Subject: Minutes of the February 21, 2008 MAGNASTOR Draft RAI Part II Teleconference
Docket No. 72-1031 (TAC No. L23764)

Draft RAI-Part II Teleconference
Docket No. 72-1031, (TAC No. L23764)
March 14, 2008

**MAGNASTOR Draft RAIs
NRC Teleconference February 21, 2008**

Figure 5.1-1 YAEC-1937 versus NAC Burnup Profile for 30-35 GWd/MTU PWR Fuel Assemblies

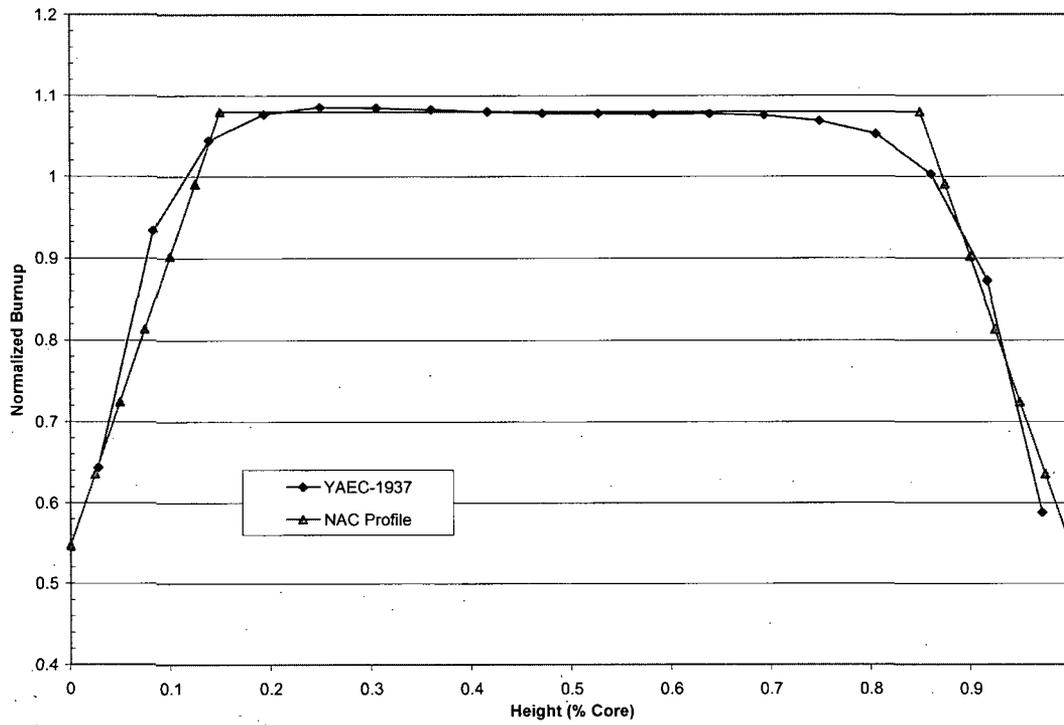
Provide information and justification on and the source term evaluation results of the fuel assemblies that contain axial end unenriched uranium blankets.

The applicant provides in Chapter 1 of this SAR a general description of the MAGNASTOR. In Sections 1.4 and 2.2, the SAR states that allowable contents include fuel assemblies containing natural uranium axial blankets. The staff, however, was unable to find from the SAR any further information on this type of fuel assemblies and corresponding shielding evaluations with these contents.

with the 30-35 GWd/MTU data from YAEC-1937 that includes blanket assemblies in the dataset. As shown the profiles match well. Discussions on the effect of variation in burnup on the profile shape are included in the response to Draft RAI 5-7 (and 5-8).

The SAR terminology section in Section 1 and definitions in Section 13 will be modified to specify the definition of assembly initial enrichment. Assembly average enrichment and average burnup definitions will include specific references to axial blankets. Text is added in Section 5.3 to clarify the origin and applicability of the burnup curves to blanketed fuel. Also included in Section 5.3 of the SAR will be the RAI response Figure 5.1-1. Both text and figure are included in the RAI 5-8 "Draft SAR Text Change" section.

**Figure 5.3-5 Normalized Burnup Profiles from YAEC-1937
(Grouped in 5 GWd/MTU Bins)**

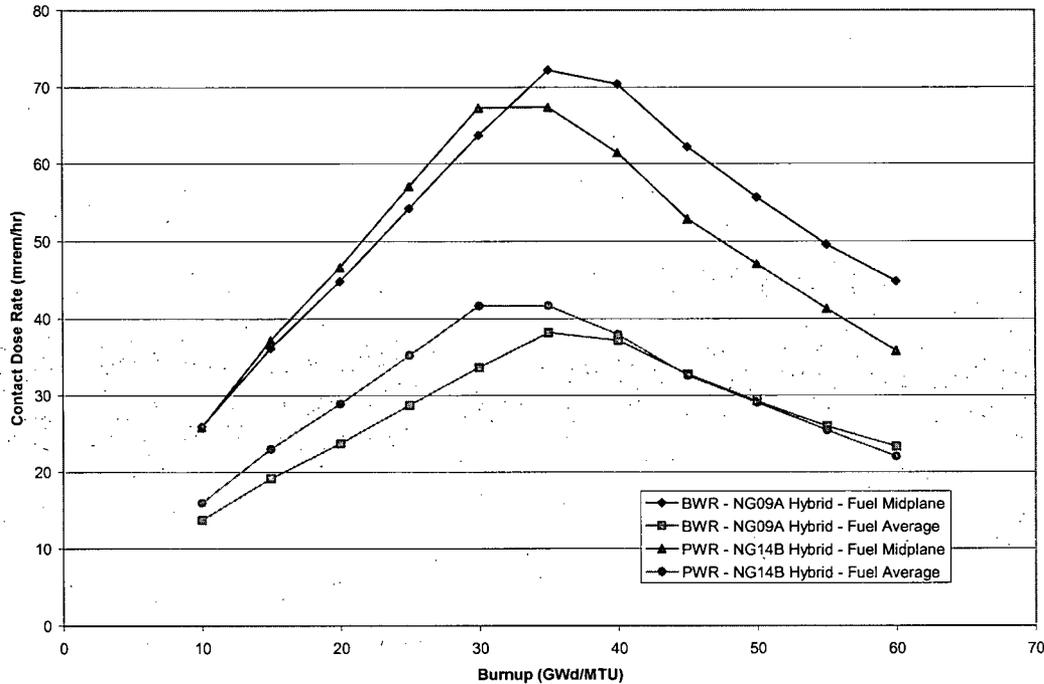
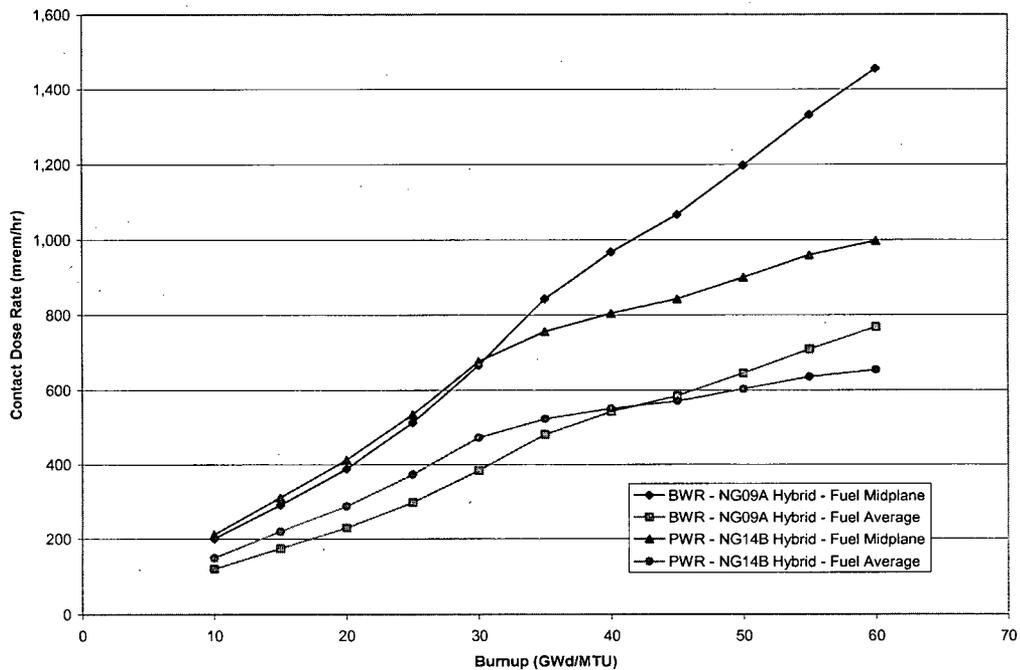
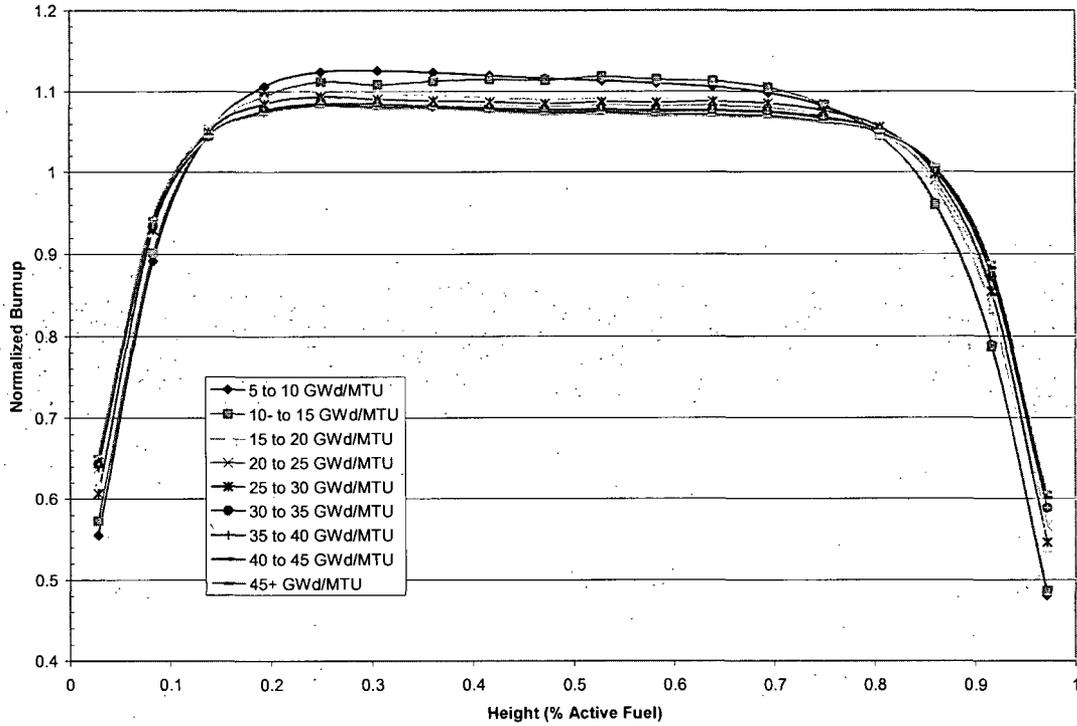
Section 5.3 of the SAR states that an axial uniform peaking factor is used in calculating the source term. The peaking factors are 1.08 for PWR assemblies based on calculated data from Seabrook and Yankee plants and measured Turkey Point gamma data. The peaking factor is 1.22 for BWR assemblies based on calculated data from Washington Public Power BWR/4-6. Studies in NUREG/CR-6801, which used a much broader spent fuel assembly database, indicate larger peaking factors and more complex burnup profiles for low burnup fuels.

As discussed in the response to draft RAI 5-8, lower burnup fuel assemblies, while displaying larger peaking factors than those obtained from >30 GWd/MTU fuel assemblies, produce significantly lower dose rates (at a fixed profile). The dose decrease is significantly larger than the peaking factor increase. Note that site dose rates (10 CFR 72.104 limit on storage systems) is driven by system gamma dose rates which are proportional to the average fuel source which decreases by 15% going from 30 GWd/MTU to 25 GWd/MTU and by over 30% shifting from 30 GWd/MTU to 20 GWd/MTU.

The SAR text in Section 5.3 is revised to identify the justification for the statement. The statement is rewritten to clarify that higher burnup fuels produce bounding dose rates and include supporting justification in terms of the dose rate plots provided in the technical discussion.

Figure 5.3-6 contains YAEC (YAEC-1937, RSICC Document DLC-201) compiled PWR burnup profiles at 5 GWd/MTU increments showing low burnup fuel having a higher peak. Peaking is less than 10% higher for the low burnup material, which is a smaller increase than the dose decreases plotted in Figure 5.3-3 and Figure 5.3-4 for the lower burnup fuels. The following discussion therefore describes the burnup profile for fuel burned in excess of 30 GWd/MTU. The 30 GWd/MTU derived profile is applied in the shielding evaluations summarized in Sections 5.1 and 5.6 and detailed in Section 5.8.

Figure 5.5-7 NAC-CASC "Black Body" Assumption Test along Short (X-Axis) Side of Array

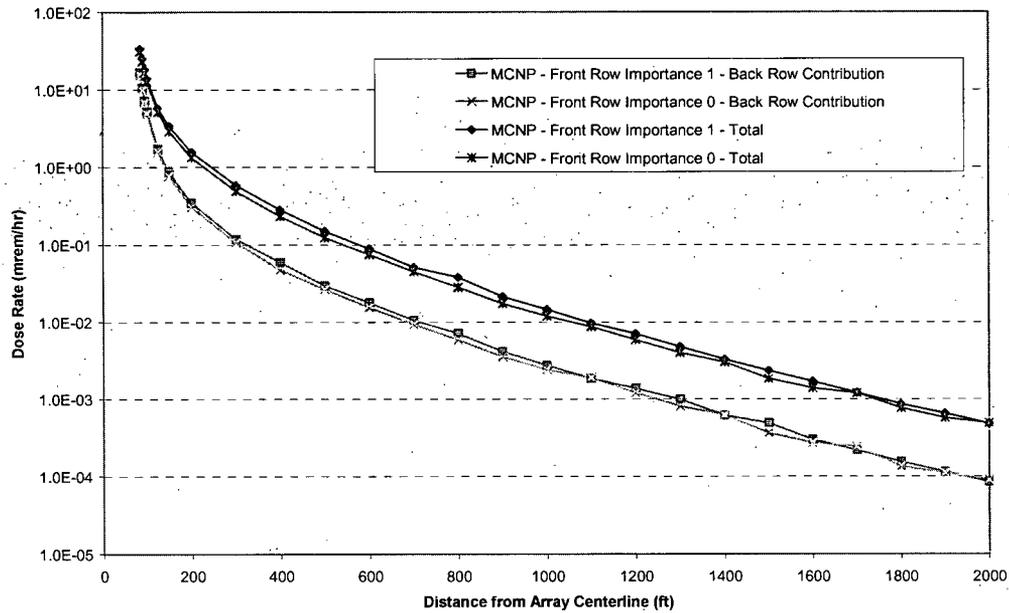
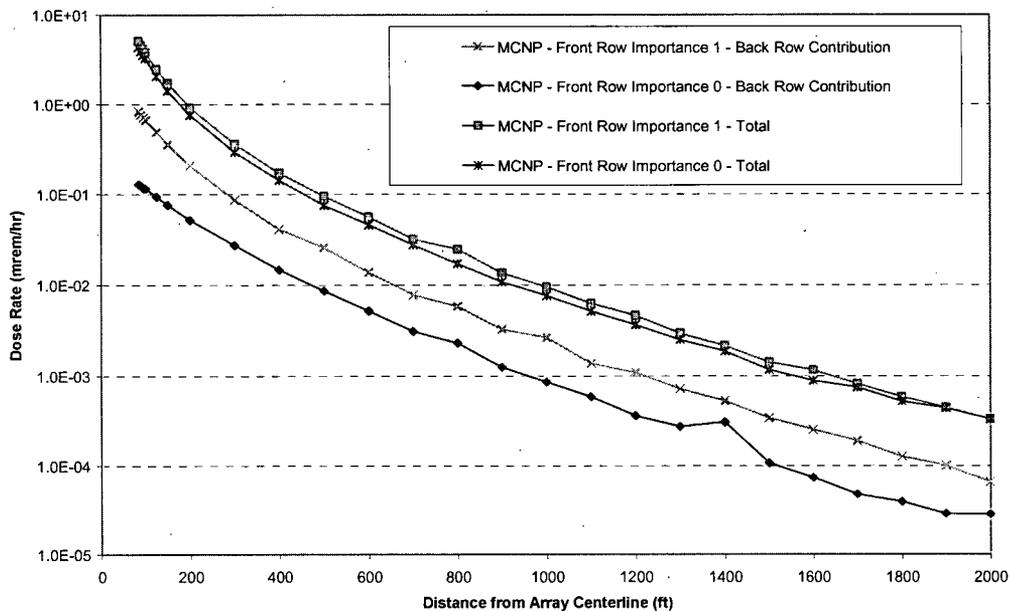
(e) Provide explicit definition of the term "cask self-shielding." Provide technical (including theoretical) basis for not tracking the particles that hit the cask between the source and the detector. Justify the assertion that the radiations emitted from the surface of one cask and subsequently hit an adjacent cask will not have a significant contribution to the site boundary dose rate because of the thickness of the cask concrete.

- f.) NAC agrees that radiation scatter from hard surfaces (such as the cask pad or surrounding surfaces) may play a significant role in the total dose rate around the ISFSI and the code only terminates tracks of particles directly intersecting adjacent casks. A typical cask array of 11.5 foot diameter casks does not provide a significant open area for radiation scatter from the radial surface of the "shadowed" cask to influence the off-site dose primarily dominated by the "front" row casks. Note that only particles originating from the cask radial surface have any potential to intersect casks within the skyshine array. To demonstrate that the assumption of terminating tracks does not have a significant effect on site boundary dose rates, MCNP evaluations were performed on a 2x10 cask array set with the evaluated source limited to the radial (cylindrical) surfaces of the back row of 10 casks. Dose rates are plotted in the following figure along the axis of the side facing the back row and front row of the array assuming the front row of casks are at a nominal importance (1) and at an importance of 0 (i.e., terminating the particle track). As shown in the figure, there is no significant effect of the assumption to terminate cask scattered particles.

“NAC-CASC, a modified version of SKYSHINE-III, uses the MCNP generated cask surface current to estimate site boundary exposures. NAC-CASC allows for self-shielding of casks and permits input of an angular surface current emission spectrum. In the NAC-CASC evaluations, the concrete casks are modeled as “black” body cylinders. Given the concrete cask thickness, radiation emitted from one cask and impacting an adjacent cask will not significantly impact site boundary dose rates. *To verify the acceptability of this assumption, a radial neutron and gamma source MCNP analysis was performed on a 2x10 cask array with the front row assigned either an importance of 1 (same as back row casks) or assigned an importance of 0 (terminating the particle tracking). Results of this analysis are shown in Figure 5.5-7 for the short array axis (facing the x direction 2 cask side of the array in Figure 5.5-6) and Figure 5.5-8 for the long array axis (facing the y direction 10 cask side of the array in Figure 5.5-6). While significantly affecting the radial dose contribution from the “shielded” back row of casks along the y-axis, the “black body” assumption does not significantly affect total dose rates in this direction as the majority of dose is contributed by the front row of casks (i.e., casks facing the detector). Including the axial contribution in the comparison, which is not affected by the “black body” assumption, would further decrease the relative effect of the black body assumption.* The energy and angular spectrum of radiation emitted from the cask surface are retained when transitioning from the MCNP to the NAC-CASC model.

Figure 2-3 BWR Partial Length Fuel Rod Location Sketches

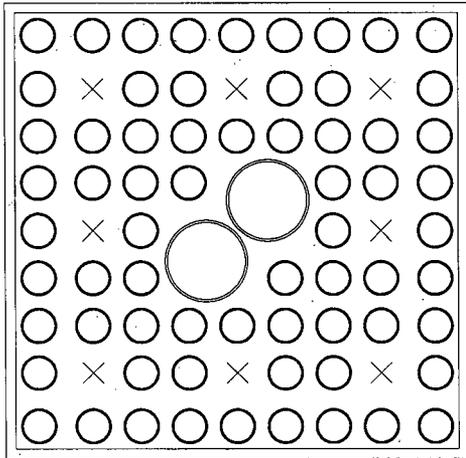
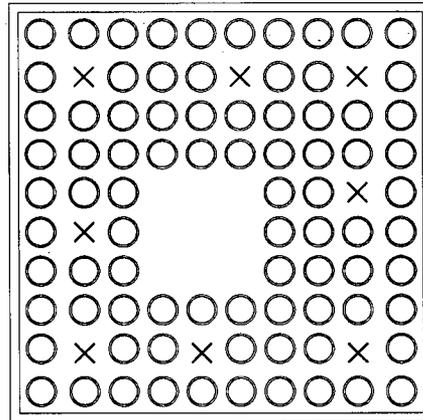
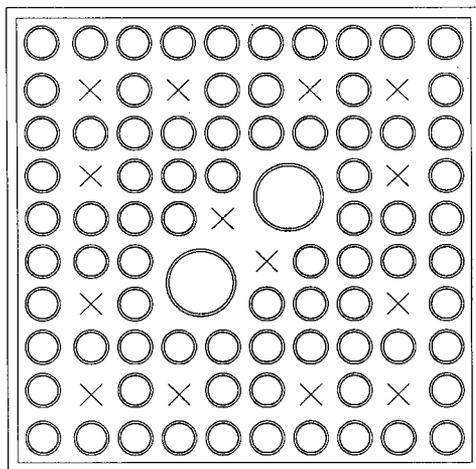
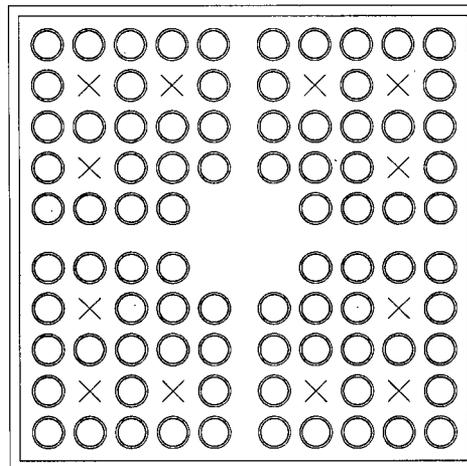
Revise Section 2.1.2 and remove Section 2.2 of the proposed technical specifications for Approved Contents to eliminate the authority to change fuel parameters in Appendix 1-A. Specify and justify which Appendix 1-A fuel parameters should be controlled in the FSAR, versus those that should be specified as an approved content in the CoC.

The staff is unable to approve this proposed change because NRC regulations in 10 CFR 72.244 prohibit a certificate holder from changing information contained in the CoC by any means other than an amendment to the CoC. Case specific alternatives to approved cask contents listed in the CoC may be submitted to the NRC review via the 10 CFR 72.7 exemption process. The staff recognizes that NUREG-1745, "Standard Format and Content for Technical Specifications for 10 CFR Part 72 Cask Certificate of Compliance" indicates that NRC believes this proposed approach and format is an acceptable means to assure the overall safety goals and removes unnecessary detail from the technical specifications. However, this format does not meet the requirement of 10 CFR 72.244. This information is need to demonstrate compliance with 10 CFR 72.236.

It is noted that NAC response to Draft RAI Part I, 13-4, has proposed the inclusion of the BWR partial length rod configuration in Appendix 1-A. It is recognized that different designs for BWR site specific assemblies may have different partial length rod array patterns and that these differences will not introduce significant impact on system criticality. Based on the known

If requested by NRC management, NAC will incorporate the information currently presented in Appendix 1-A into Technical Specification 13B Section 2.0, delete Appendix 1-A and revise Technical Specification 13A deleting reference to Appendix 1-A and Section 2.1.2.

Figure 3-1 TRANSFER CASK Surface Dose Rate Measurement

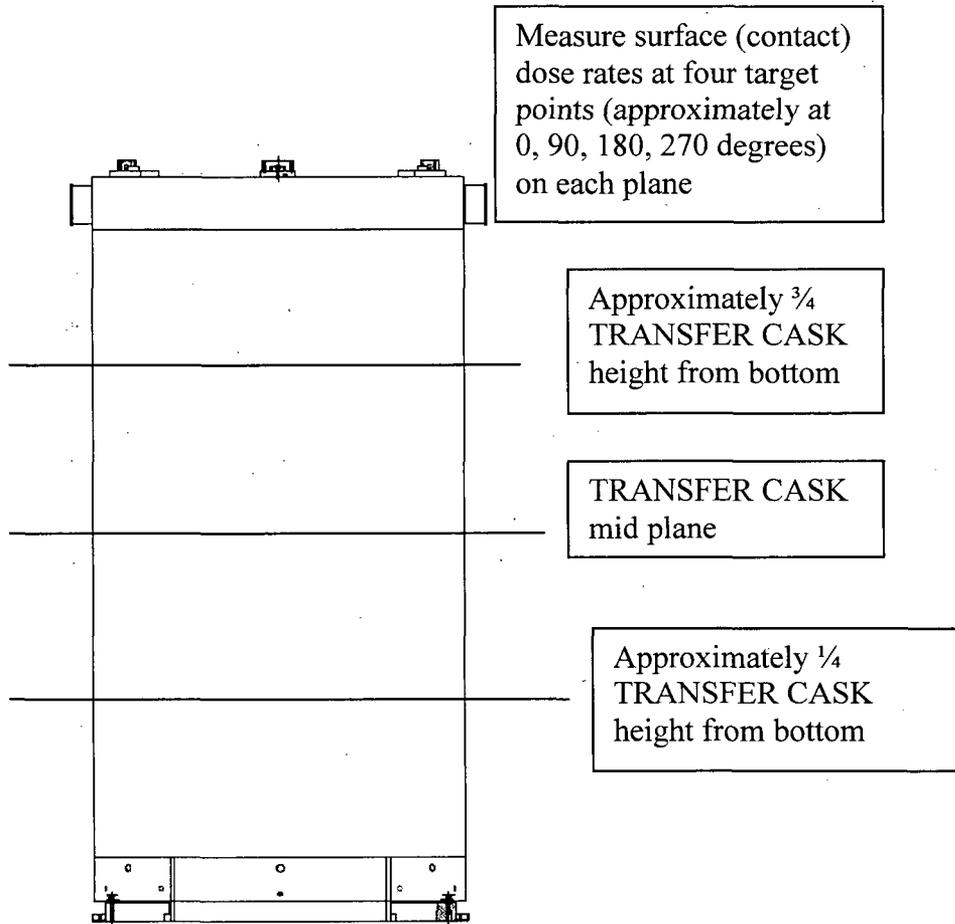
Add dose rate limits to the proposed technical specifications for the top and side of the transfer cask and the concrete storage cask.

The staff found after reviewing the dose rates and operating procedures that it is necessary to establish dose rate limits for the top and side of transfer cask and concrete storage cask. These dose rates serve several purposes. These dose rates (1) assist with gross mis-load detection and guiding ALARA planning and evaluations; (2) provide confidence that public dose limits will not be exceeded; (3) confirmation of the modeling results at the transfer cask surface gives confidence in the doses calculated at other distances; (4) confirms that the values used as the basis for the radiation protection analyses in the SAR and the site-specific Part 20 ALARA planning was appropriate; and (5) serves to maintain the shielding characteristics of the approved design without unduly restricting the changes that may be made under 10 CFR 72.48.

| SURVEILLANCE | FREQUENCY |
|--|----------------------------|
| SR 3.3.1.1 Verify average surface dose rates of TRANSFER CASK loaded with a dry CANISTER containing dry fuel assemblies are within LCO limits. Dose rates shall be measured at the locations shown in Figure 3-1. | During TRANSFER OPERATIONS |
